ARKANSAS POWER & LIGHT COMPANY

SUBJECT: Arkansas Nuclear One - Unit 1
Docket No. 50-313
License No. DPR-51
ANO-1 Inservice Inspection Program Response
to Request for Additional Information

ATTACHMENT TO 1CAN018507

FIG. IWB-2500-14 SUPPORT CIRCUMFERENTIAL WELD JOINT

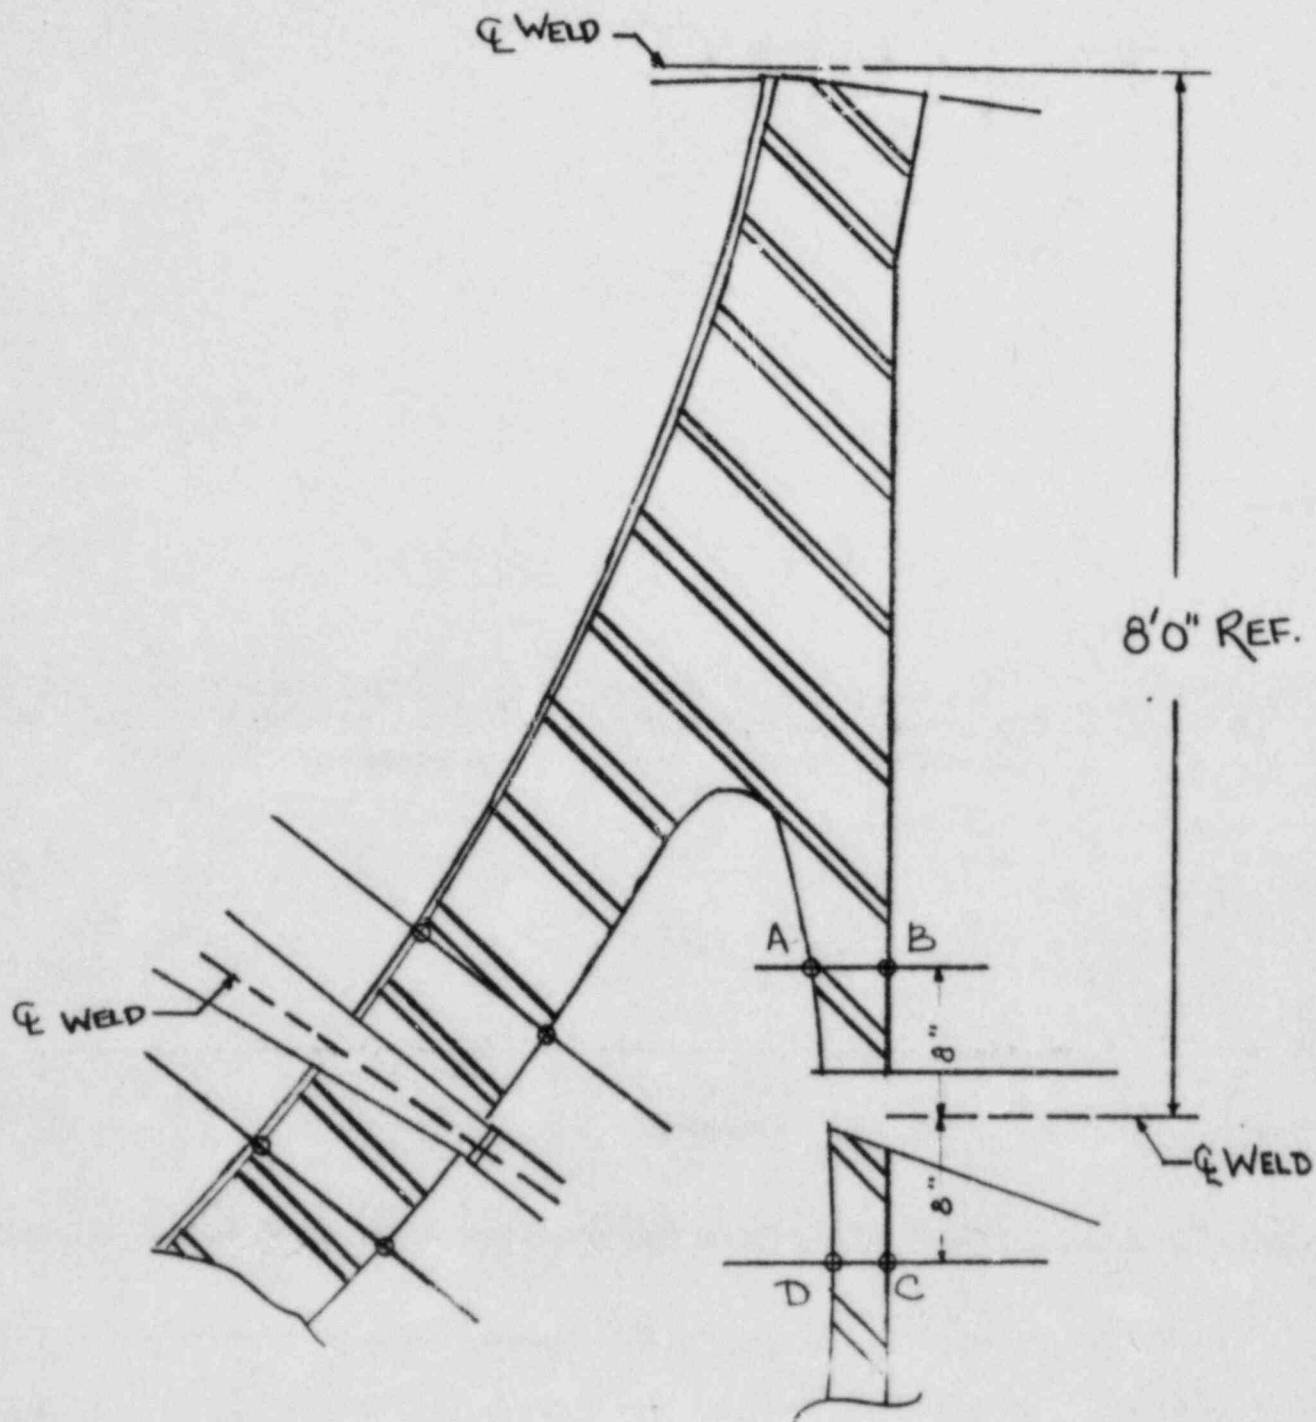
- "2. The second relief request on page 2 of Reference 1 concerns NDE of the reactor vessel support skirt-to-vessel weld. Figure 1 of the reference showing a section of this structure is unclear, and the labeling is not readable. Please supply a copy of this drawing that clearly shows the dimensions of interest."

This drawing has been redrawn with emphasis on the welds. A copy of the revised drawing is enclosed as requested.
